Our Ref: 2112XX-20457-Prelim BCA Review

BCA REVIEW			
Project Title:	BCA AUDIT		
Project Address:	46 TENNYSON STREET, ELWOOD		
Reference No.	20457	Date:	17/01/2022

BUILDING PROJECT PROFILE	
Site Name:	Elwood Childcare Centre
Property Address:	46 Tennyson Street, Elwood
Description of Works:	Site inspection
BCA Version:	2019 Amendment 1
Classification:	Ground floor Childcare – Class 9b First Floor Office – Class 5
Use:	Childcare
No. of Storeys:	2
Rise in Storeys:	2
Type of Construction:	Type B
Effective Height:	4m
No. of Occupants: (BCA D1.13)	36 children 10 staff
Floor Area:	Ground floor – 259.41m ² First Floor – 72m ² Total – 331.41m ²

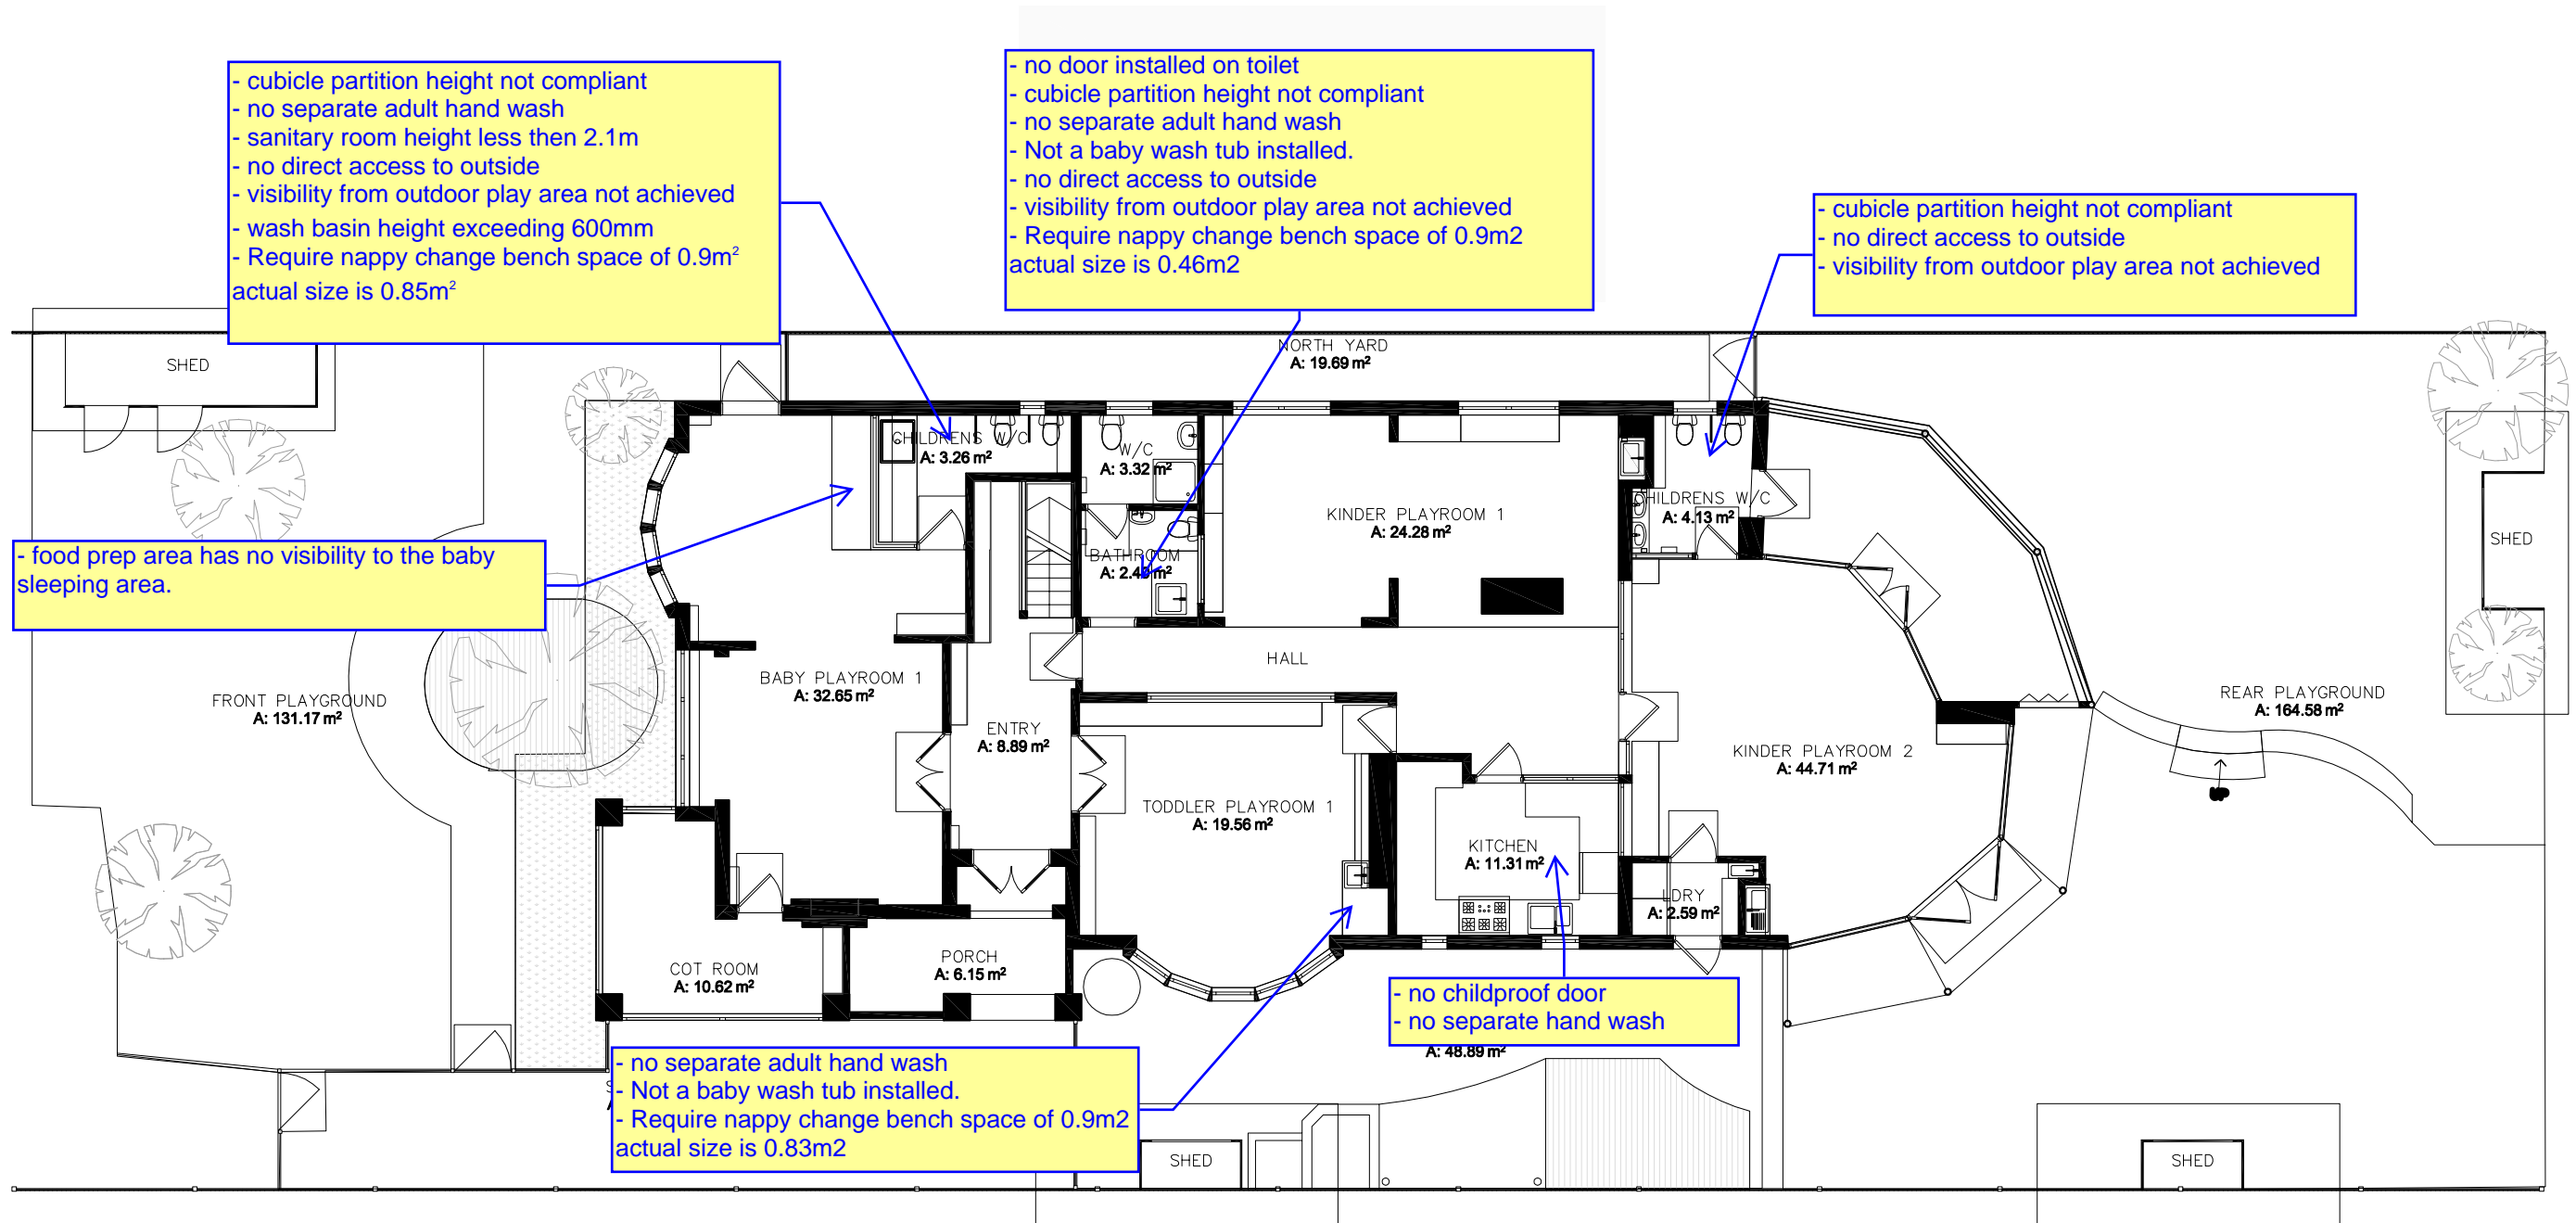
BCA ITEMS			
BCA Clause		Compliance Comments	Compliance Status
F1.13	Glazing Assemblies	All glazing assemblies required to comply with AS1288 & AS2047	Glazing did not have any Australian standard markers on the window therefore could not determine compliance with BCA provisions in the absence of destructive testing and manufacturers specifications.
F1.7	Waterproofing of wet areas	Walls and floors within wet areas required to be waterproofed	All wet areas have water resistance material such as tiles and vinyl. Could not determine compliance with BCA provisions in the absence of destructive testing and manufacturers specifications.
F2.2	Calculation of number of occupants & facilities	Require to provided separate male and female facilities. Faculties are not permitted to be shared between children and staff.	Toilet facilities provided is only a unisex toilet. However, this toilet does not comply with AS1428.1 provisions.

CITY OF PORT PHILLIP
 ELWOOD CHILDCARE CTR
 46 Tennyson Street, Elwood
 (CHS-222)

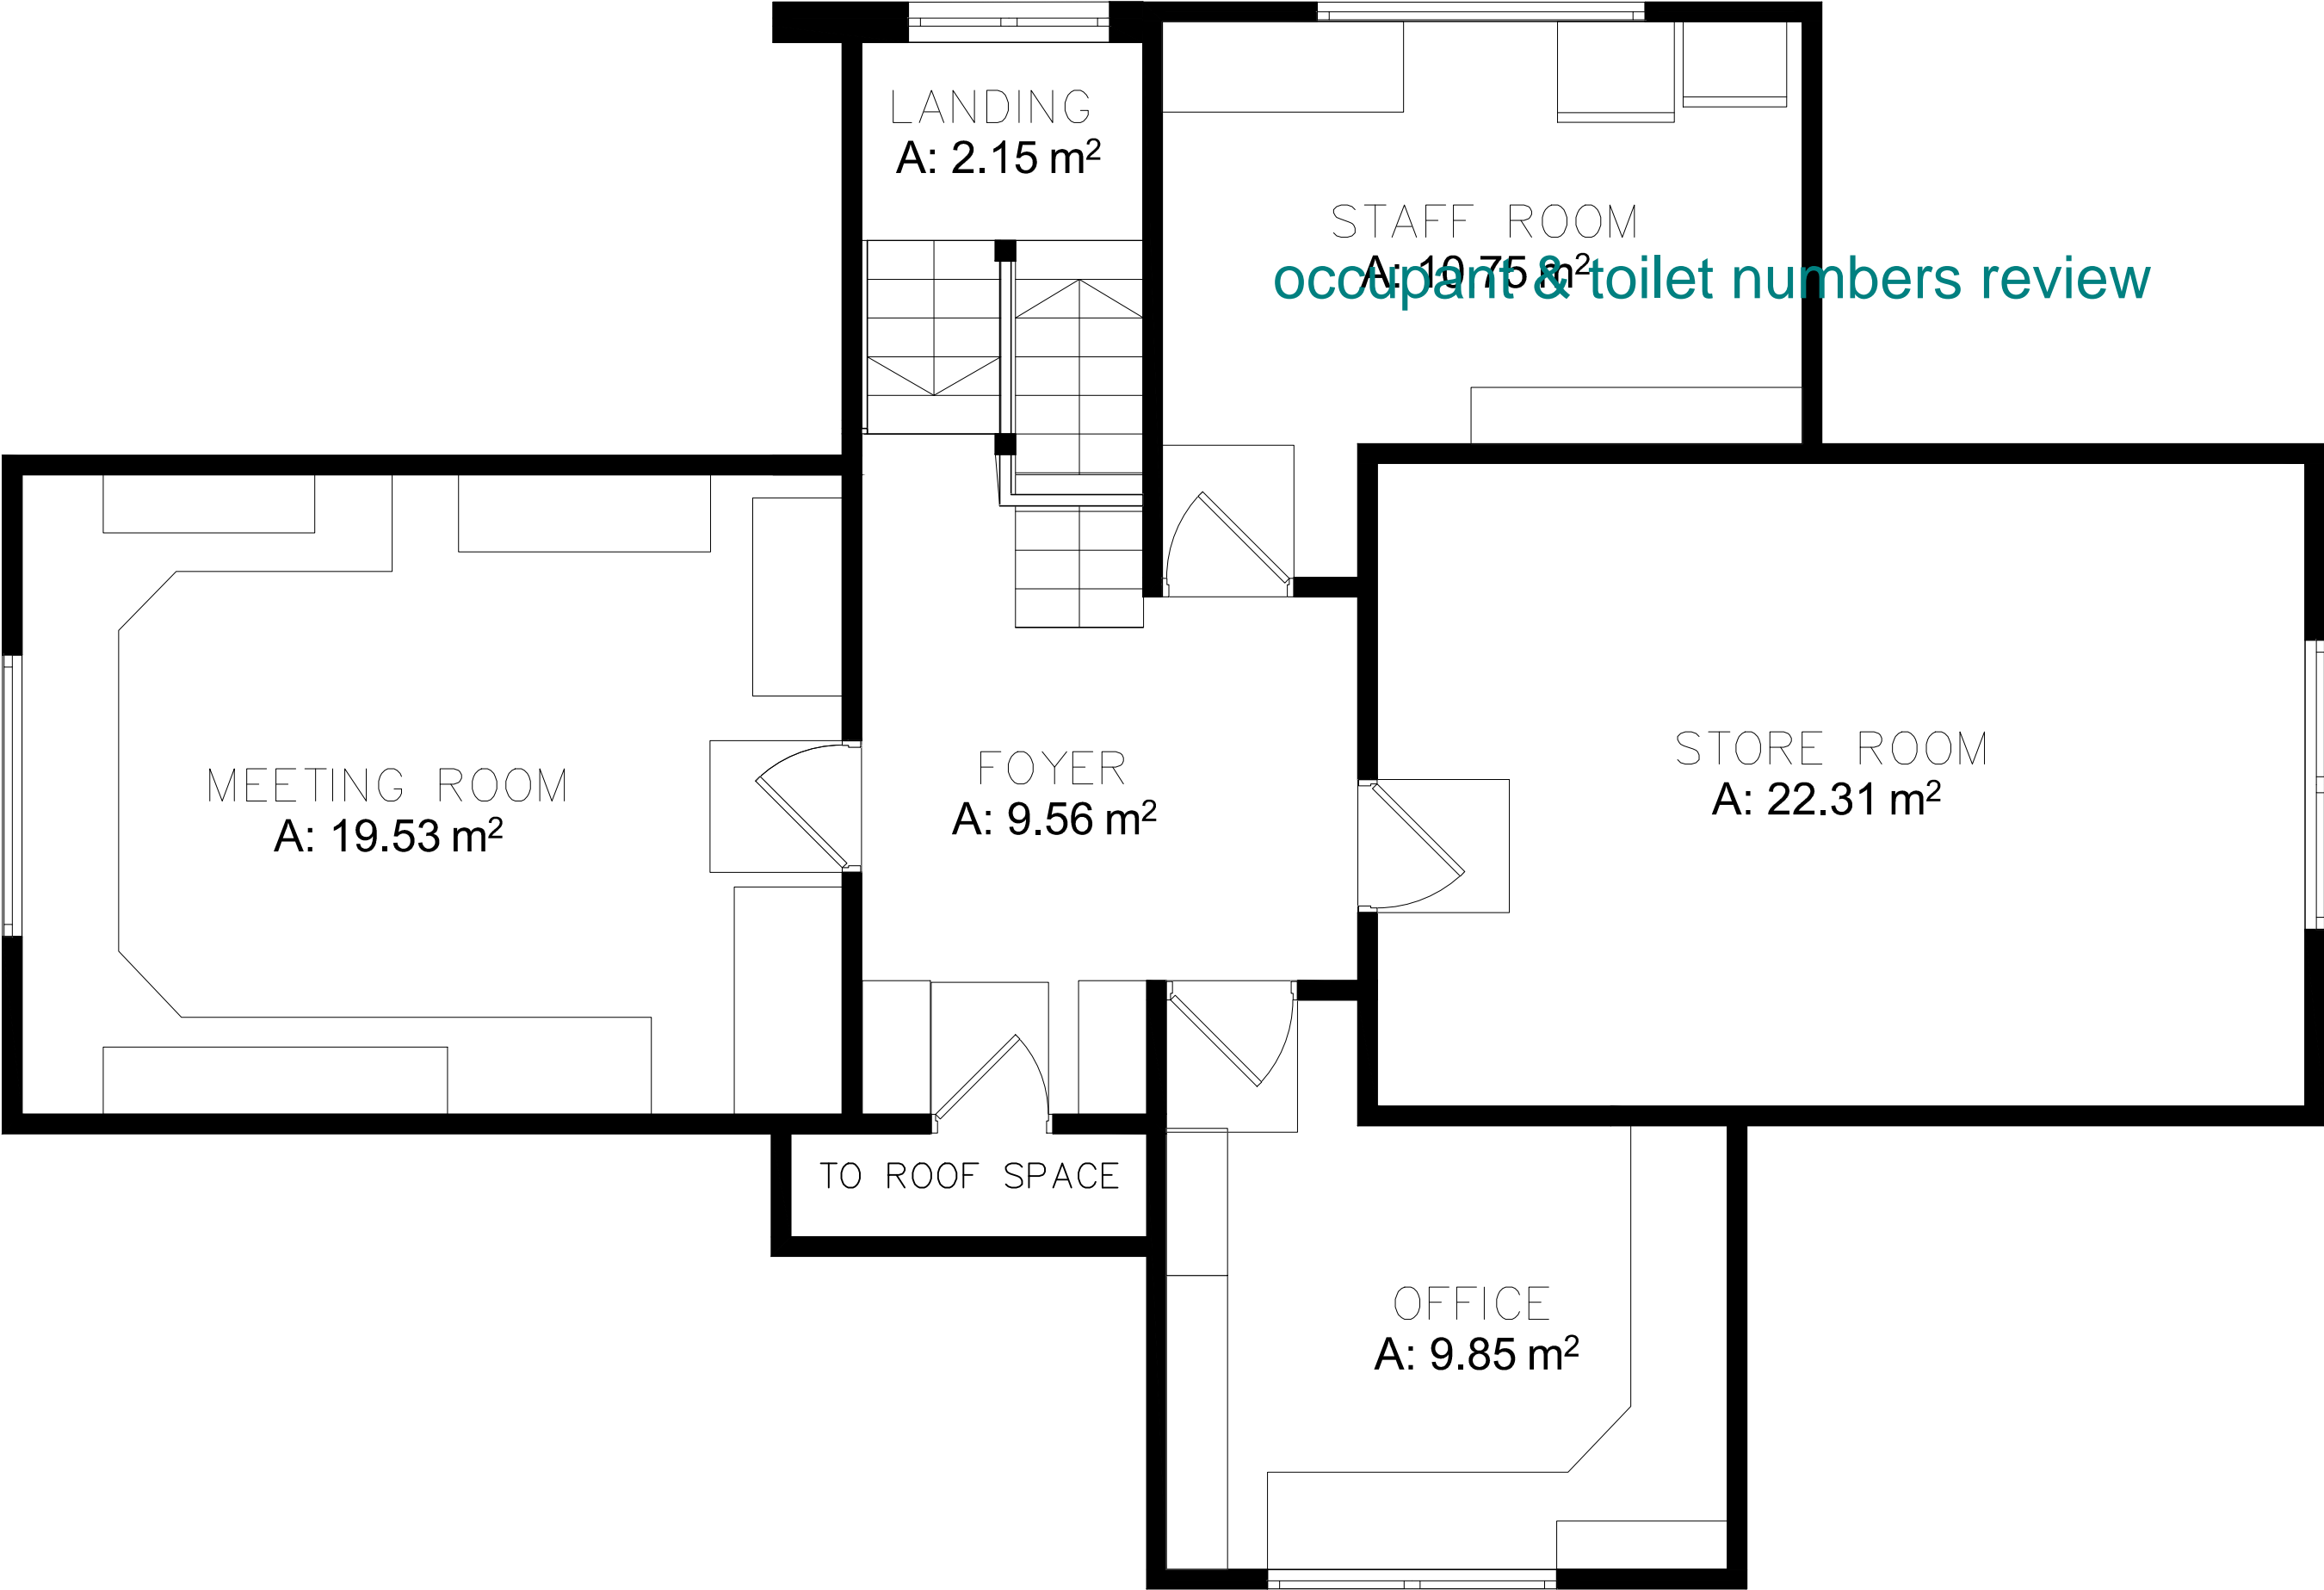
BCA ITEMS			
BCA Clause		Compliance Comments	Compliance Status
F2.3	Facilities in Childcare centre	<p>Kitchen</p> <ul style="list-style-type: none"> ➤ Sink ➤ Hand washing facility ➤ Refrigeration ➤ Cooking facilities ➤ Door or gate with childproof latch. <p>Bathroom</p> <ul style="list-style-type: none"> ➤ 1 bath, shower, or shower/bath <p>Toilets</p> <ul style="list-style-type: none"> ➤ Junior pan ➤ Washbasins rim height not exceeding 600mm high ➤ Accessible from both outdoor and indoor play areas. ➤ Toilets able to be observed by staff from outdoor and indoor play areas. <p><u>In addition to 3yr childcare centre</u></p> <p>Kitchen</p> <ul style="list-style-type: none"> ➤ Ability to able to supervise the children (2yrs) from prep area or kitchen <p>Laundry</p> <ul style="list-style-type: none"> ➤ Washtub ➤ Washing machine <p>Bathroom</p> <ul style="list-style-type: none"> ➤ Bench type baby bath ➤ Nappy change bench within 1m of the baby bath bench. <p>Nappy change bench</p> <ul style="list-style-type: none"> ➤ Separate Adult hand washing facility within 1m of the nappy change bench ➤ Not less then 0.9m² nappy change bench ➤ Bench height between 850mm-900mm ➤ Step ladder and storage for steps 800mm high, 500mm wide, 800mm deep ➤ Staff to have visibility (window) from the nappy changing bench towards children play area 	<p>BCA Compliance has not been achieved.</p> <p>Refer to attached mark up</p>
